# COUNCIL PUBLIC HEARING

1. AP.2.24 through AP.6.24 - Appeal of Planning Commission Decisions to Build a Triplex with Multiple Variances on Wyeth Street (Dan Hatfield)

**CITY OF ST. HELENS PLANNING DEPARTMENT  
STAFF REPORT**

**Appeal AP.2.24 – AP.6.24 (CUP.2.24 & V.8.24 - V.11.24)**

# SITE PLAN

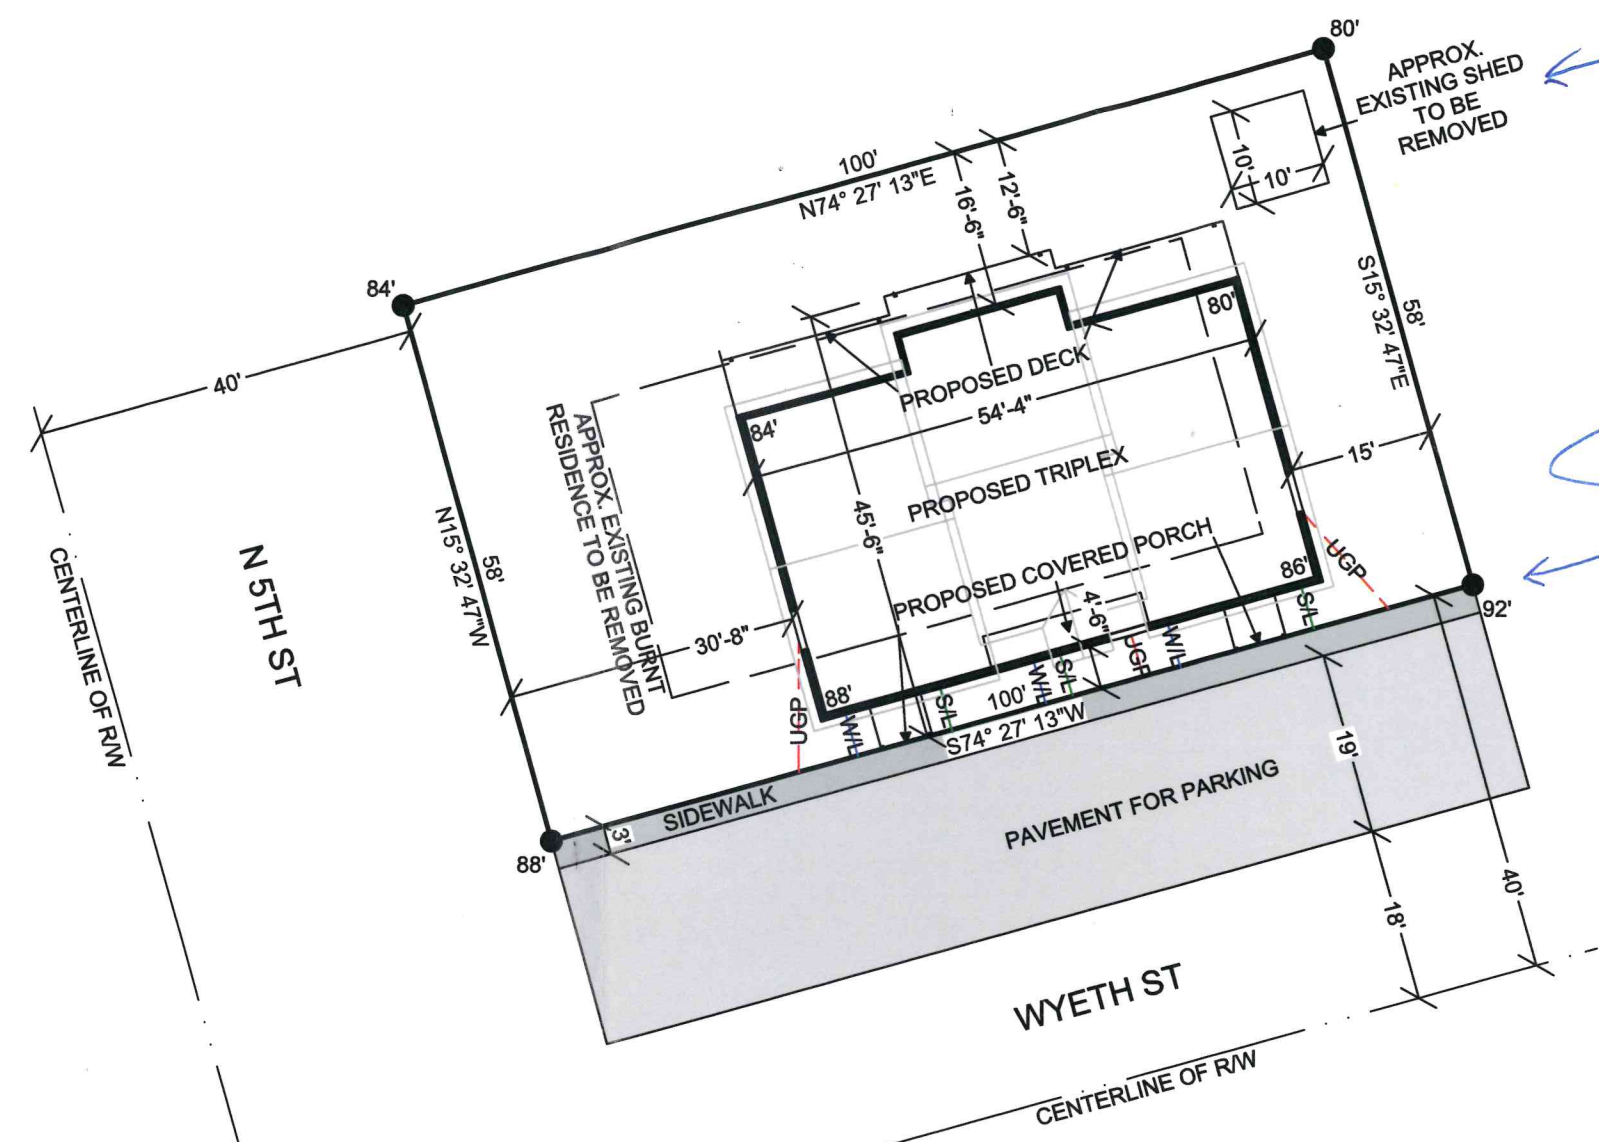
Min exterior yard (corner lot) along Wyeth is 10 feet. Site plan shows 4.5 feet. **Need Variance:** see V.9.24. This was denied by the Commission.

Non-living windowed room areas are along the Wyeth Street side of the building. Provided the existing sidewalk does not move (which is shown incorrectly on the preliminary plans as the sidewalk does not abut the property line), there should be 8' of separation, but maybe not 10 feet. Living room areas are proposed on the opposite side of the building from Wyeth Street.

**FRONT ELEVATION**  
SCALE: 1/4" = 1'-0"

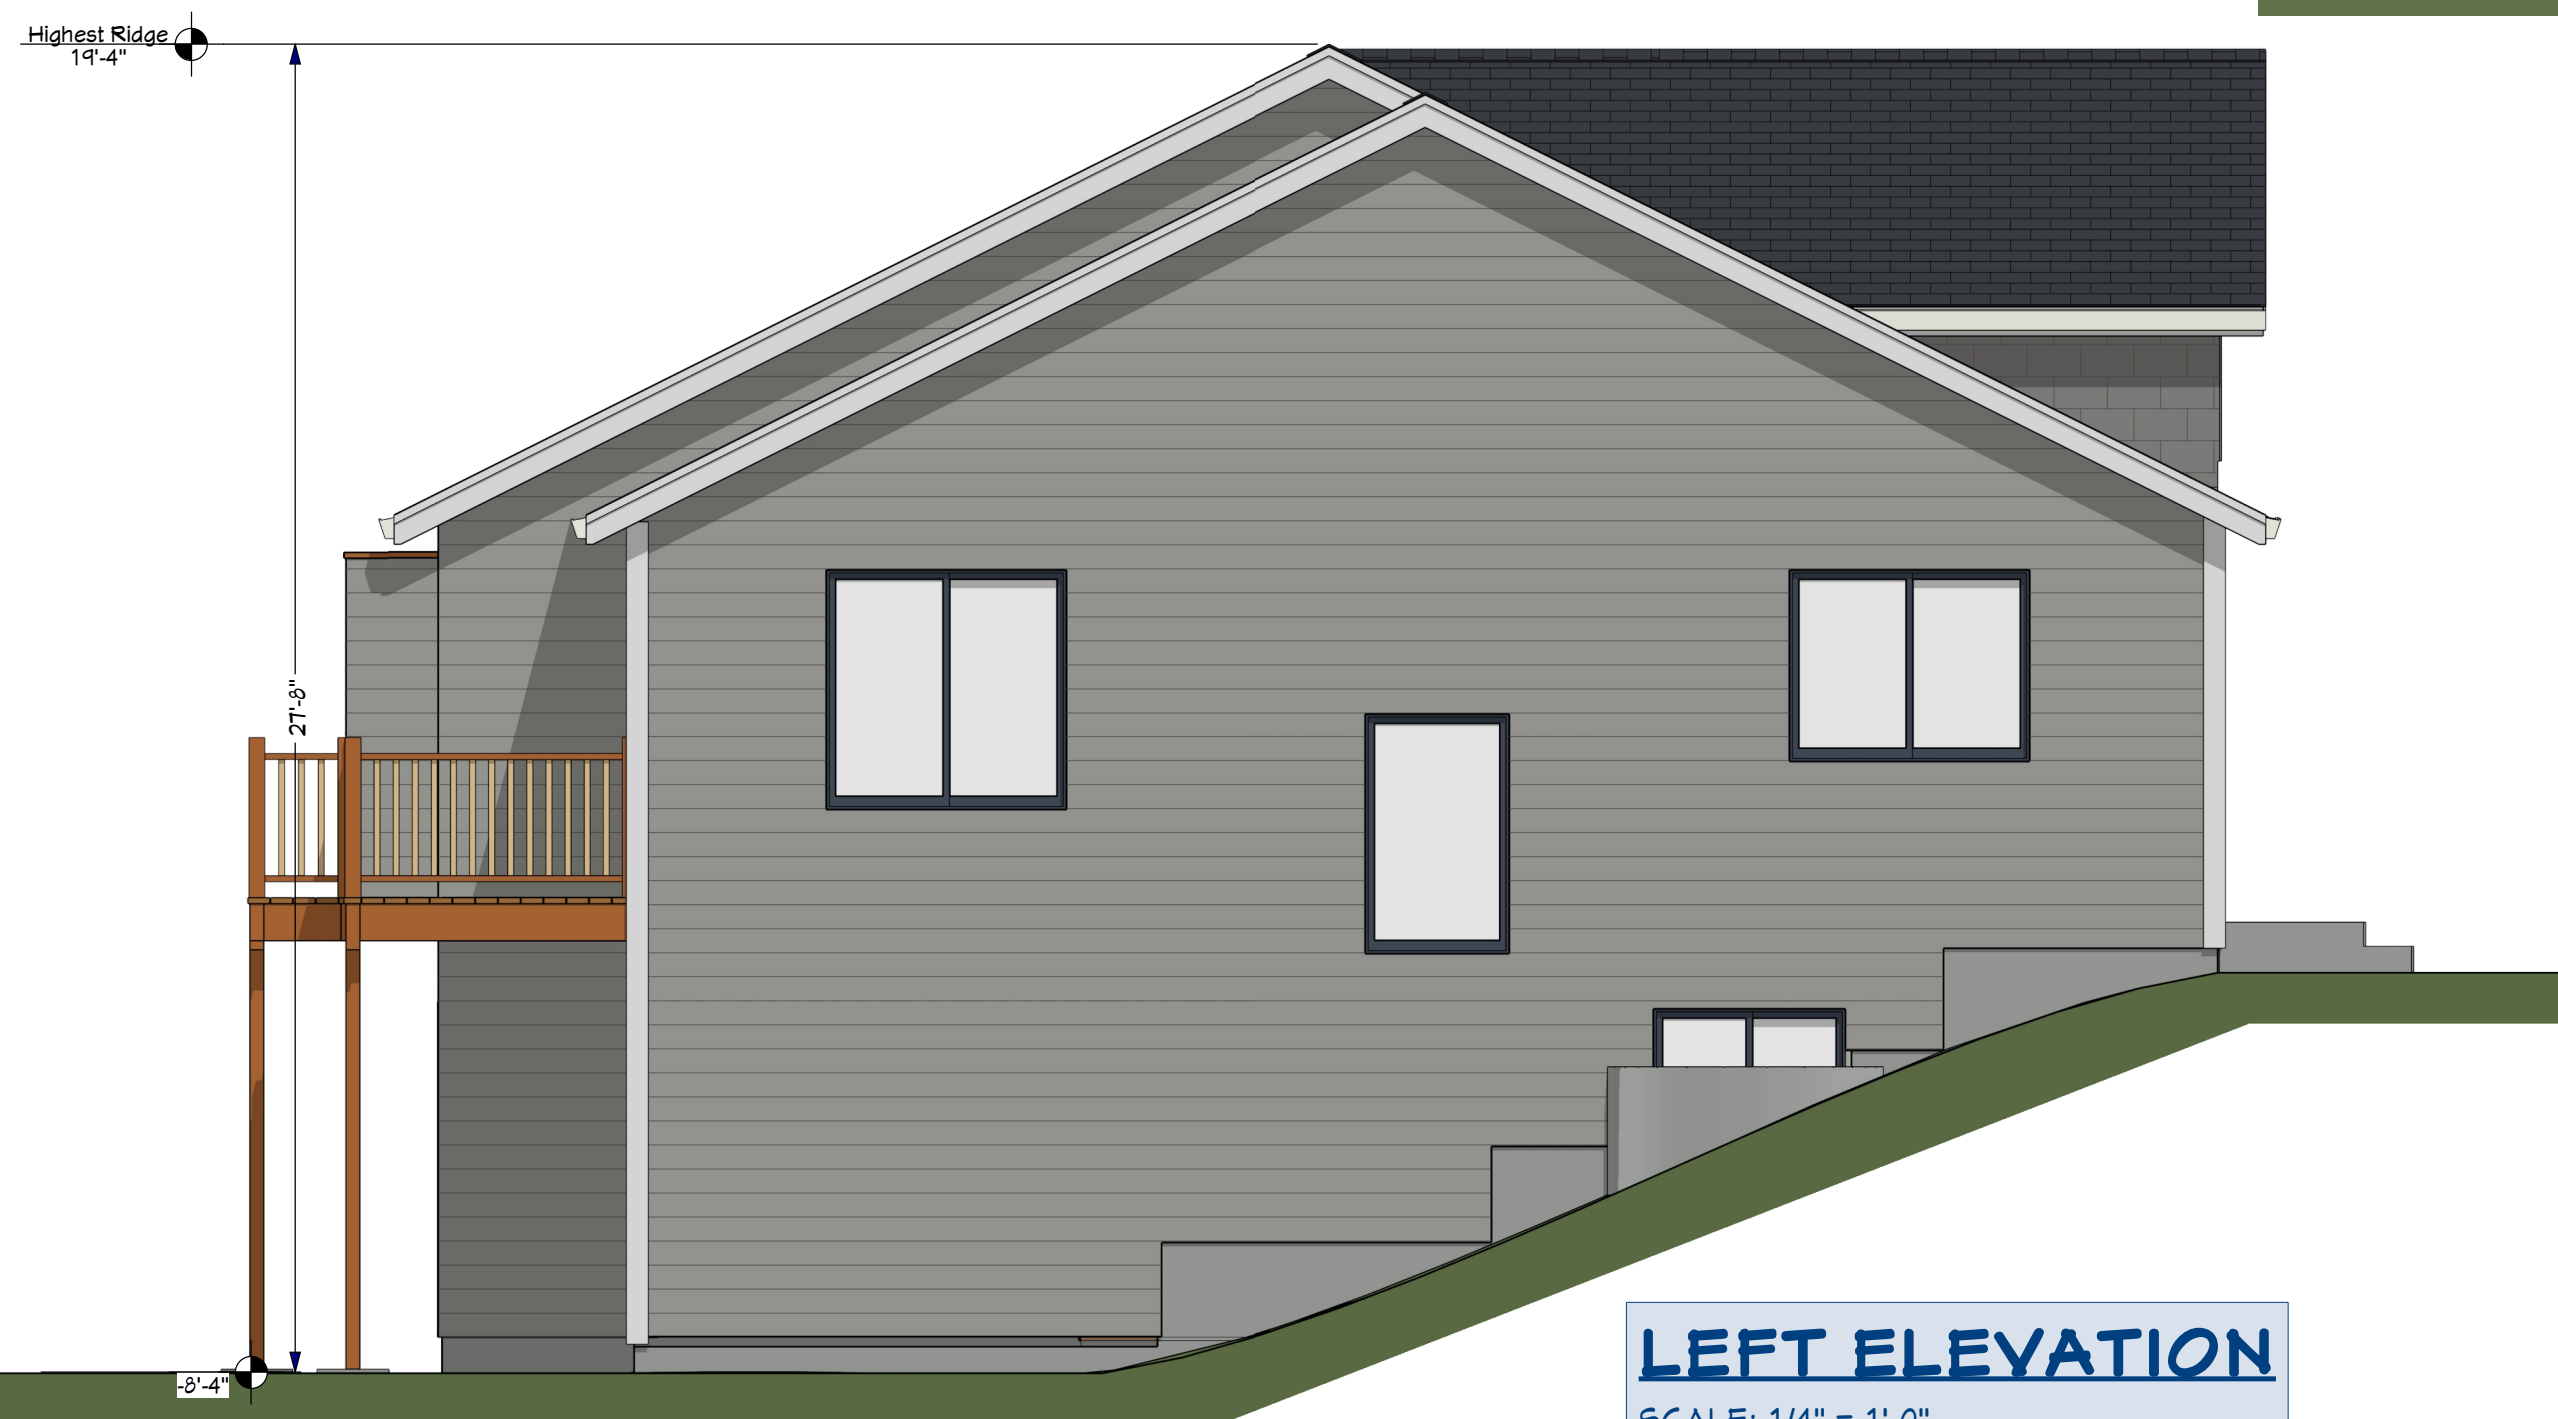
This is not met, but the proposed building has some offsets, but not 8’ ones and the roof line break is only one foot. This doesn’t necessarily kill the CUP by itself, but significant plan modification would be necessary.
